Re: Joint Draft Environmental Impact Report/Environmental Impact Statement (EIR/EIS) for
East County Substation Project (State Clearinghouse No. 2009121079; DOI-BLM-CA-D070-
2010-0027-EIS (ECO SUB))

San Diego Gas & Electric Company (SDG&E) submits the attached comments to the California Public Utilities Commission (CPUC) and United States Department of Interior, Bureau of Land Management (BLM) on the Joint Draft Environmental Impact Report/Draft Environmental Impact Statement (EIR/EIS) for the proposed East County Substation Project (ECO Substation Project or Project).

Figure A-1: February 2011 ECO Substation Design

Figure A-3: Preliminary Underground Alignment Drawing 1 of 10

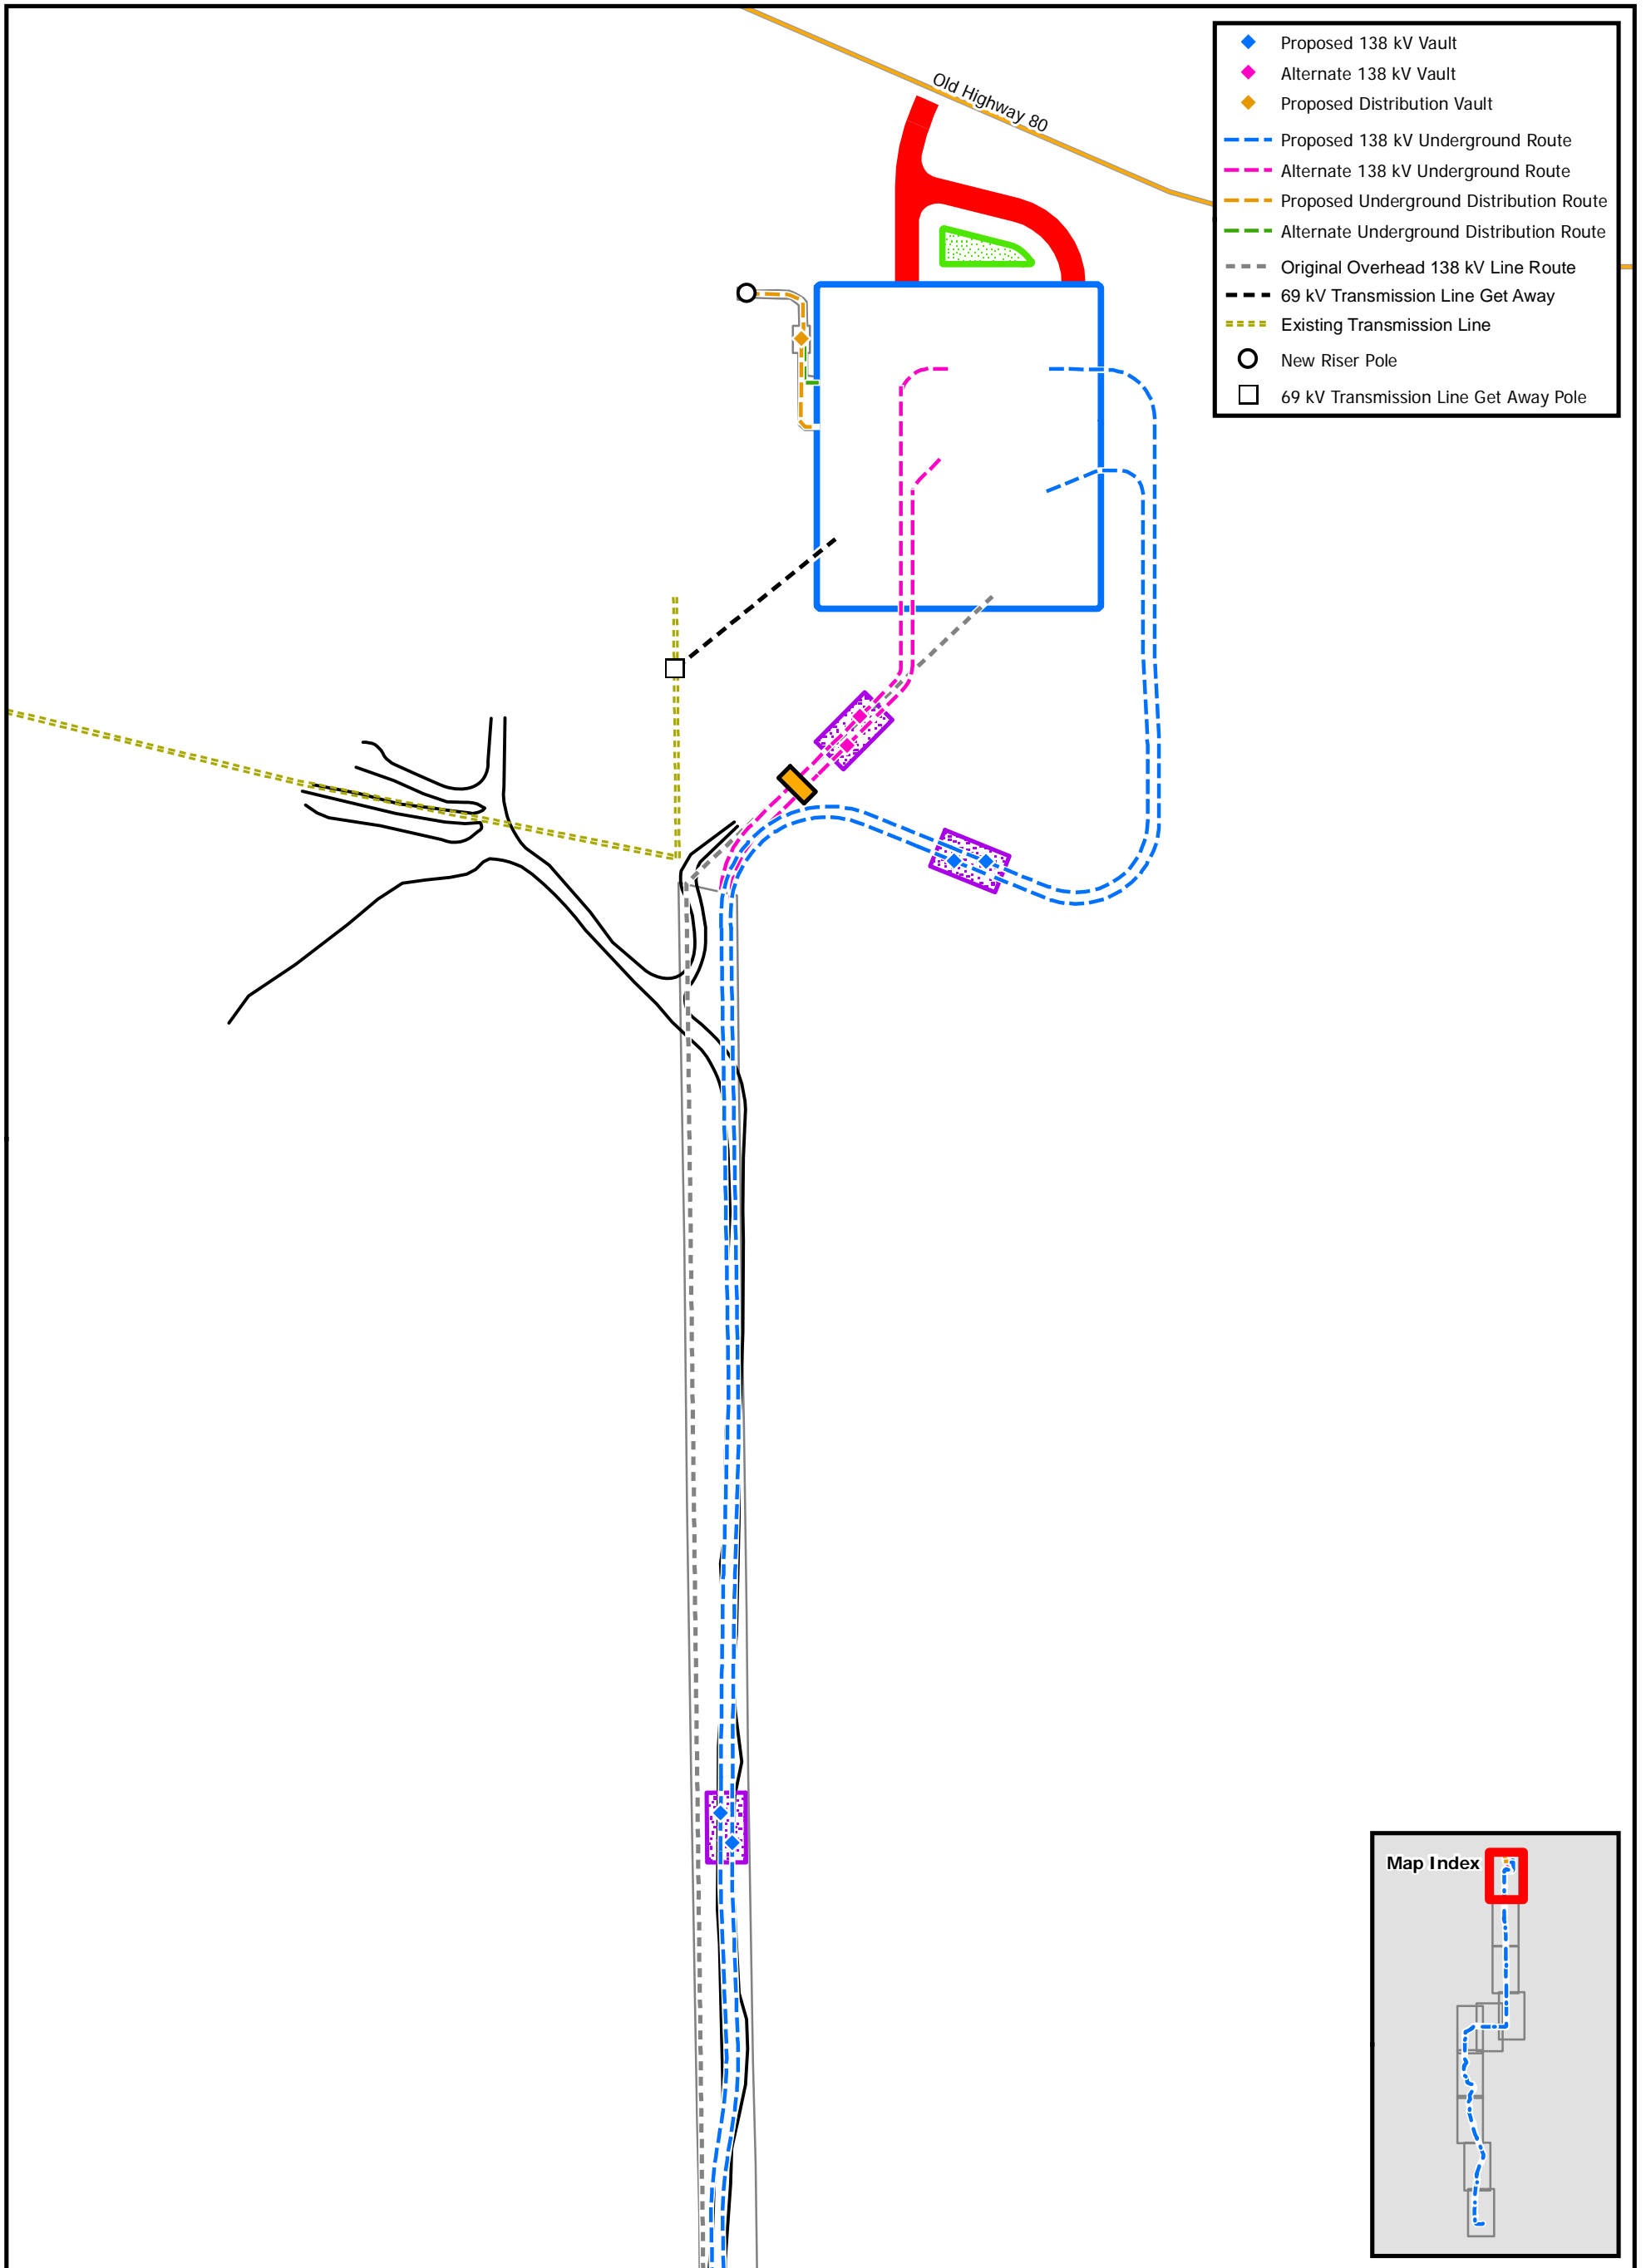
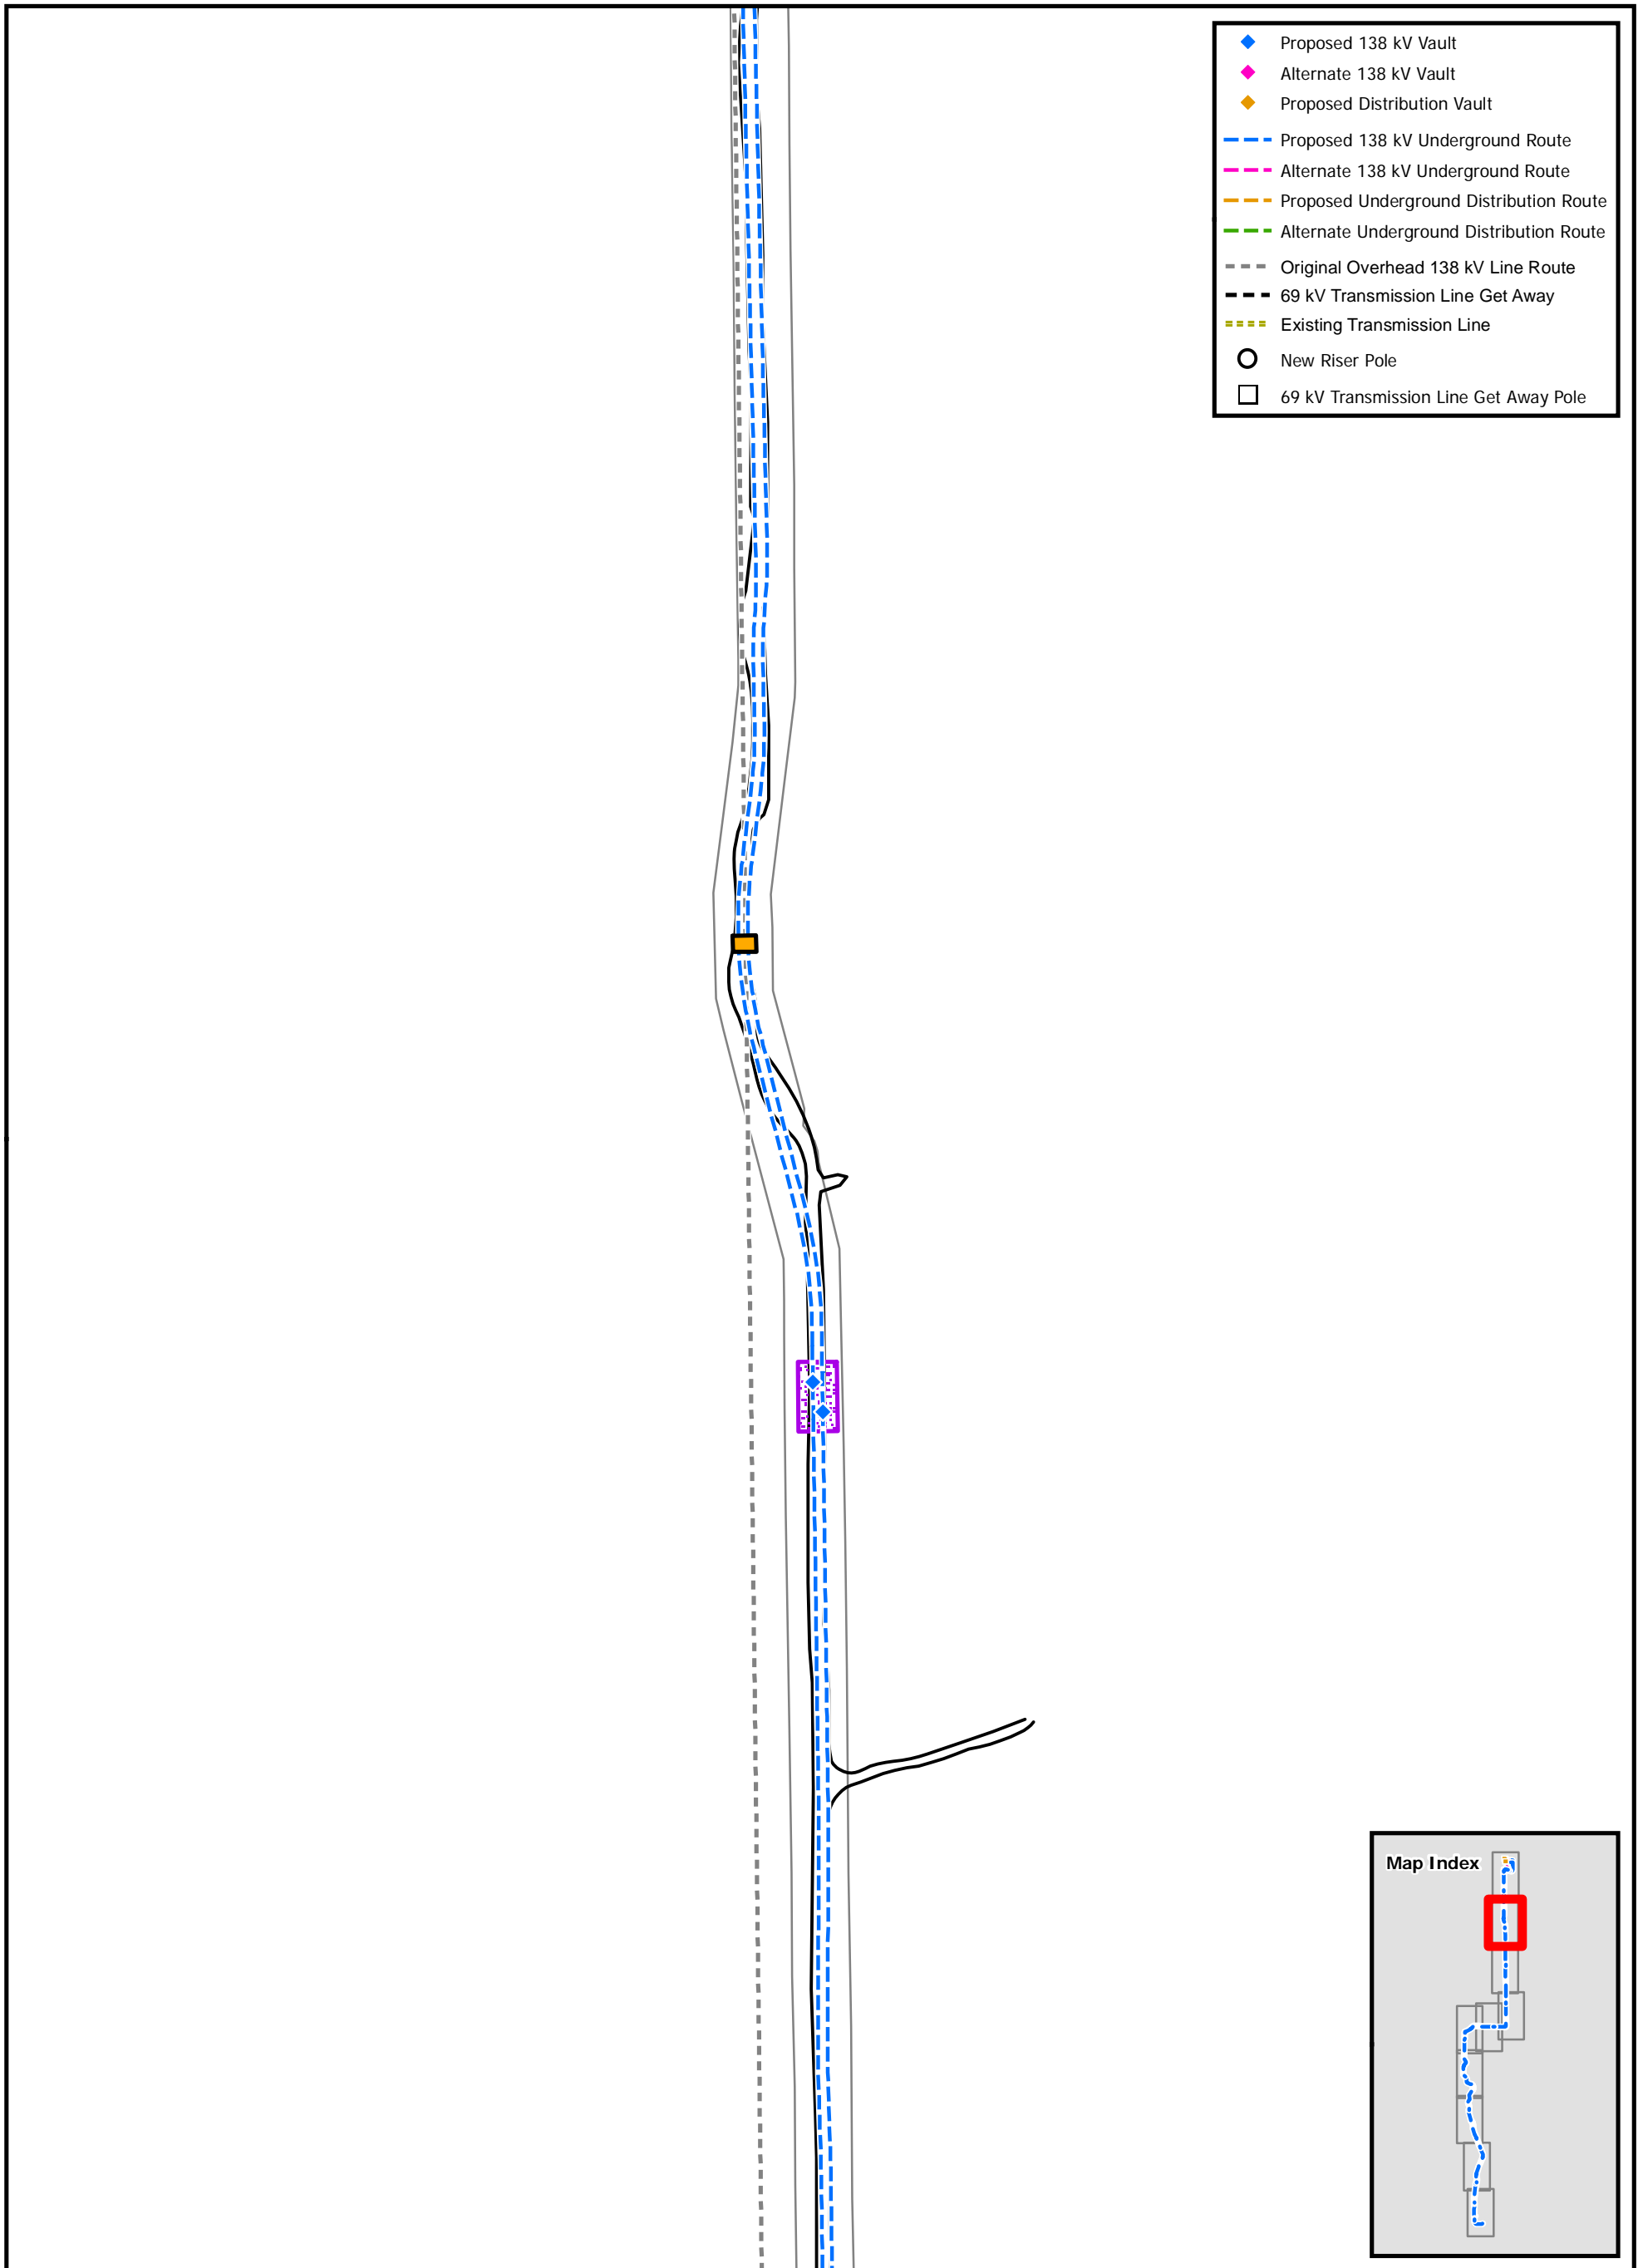
The impacts of the underground alignment were then determined based on a worst-case scenario (since there are two alternative routes into the substation as depicted in Figure A-3: Preliminary Underground Alignment Drawing that are substantially similar). As demonstrated in Table A-7: Preliminary Partial Underground Impacts, these impacts would not be substantial and would not therefore be significant.
